# CITY OF NEWTON Department of Public Works ENGINEERING DIVISION

#### **MEMORANDUM**

Re: Special Permit – 39 Herrick Road

Topographic Site Plan
Showing Proposed conditions at
Herrick Road
Newton, MA
Prepared by: VTP Associates, Inc.
Dated: January 4, 2017

Existing public path and pedestrian curb cut & cross walk

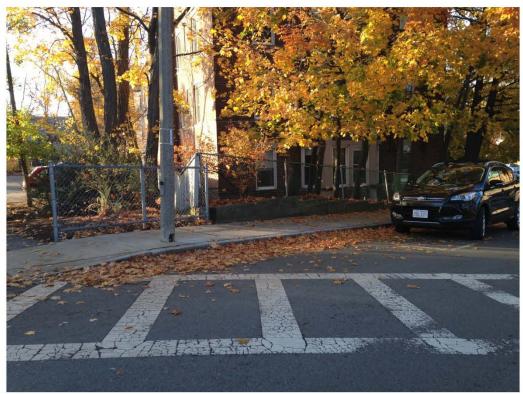
The site plan does *not* show the pedestrian curb cut (a.k.a. HP ramp) and marked cross walk that provides pedestrian and wheel chair access from the City owned footpath that connects (Cypress Street & Herrick Road) which numerous pedestrian utilize to get to the MBTA *Newton Centre* Greenline stop at Union Street. Clarification is needed how the crosswalk, pedestrian ramp and proposed driveway will function.
